**RE: SUTHERLAND ENTERTAINMENT CENTRE REDEVELOPMENT
BCA & DDA COMPLIANCE STATEMENT FOR DA SUBMISSION**

This statement has been prepared to verify that Blackett Maguire + Goldsmith Pty Ltd have undertaken a high level review of the architectural documentation that will accompany the Development Application to Sutherland Shire Council for the proposed redevelopment of the Sutherland Entertainment Centre against the Building Code of Australia 2019 (BCA).

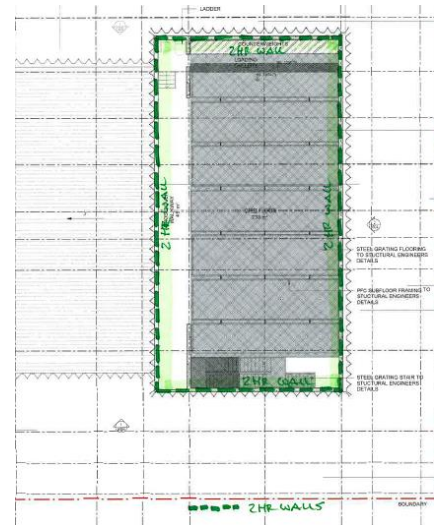
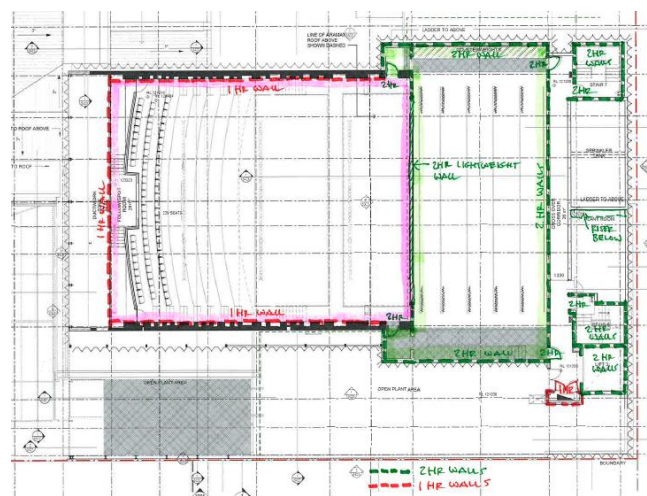
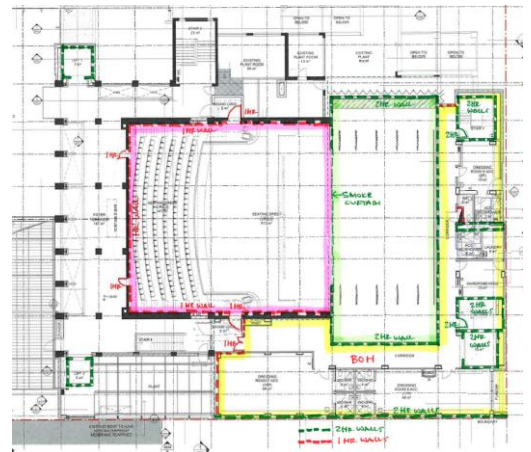
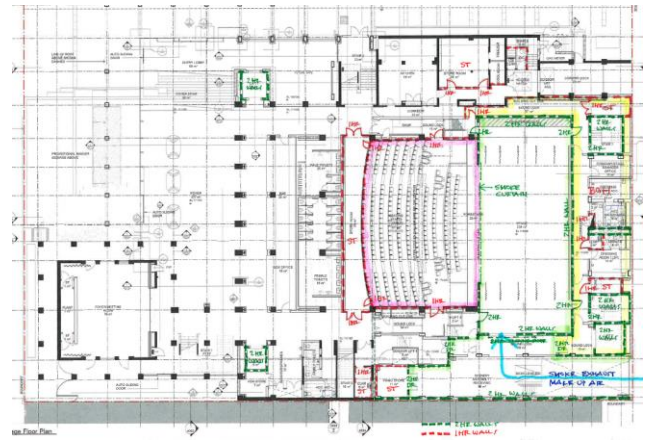
Spec C1.1	<p><u>Fire-Resisting Construction:</u> The building is required to comply with Table 3 as relevant to FRLs required for buildings of Type A Construction.</p> <p>Fire separation and compartmentation will generally be adopted as per the below strategy (subject to review with the fire safety engineer):-</p>

Comment: The FER strategy will address required and rationalised FRLs.
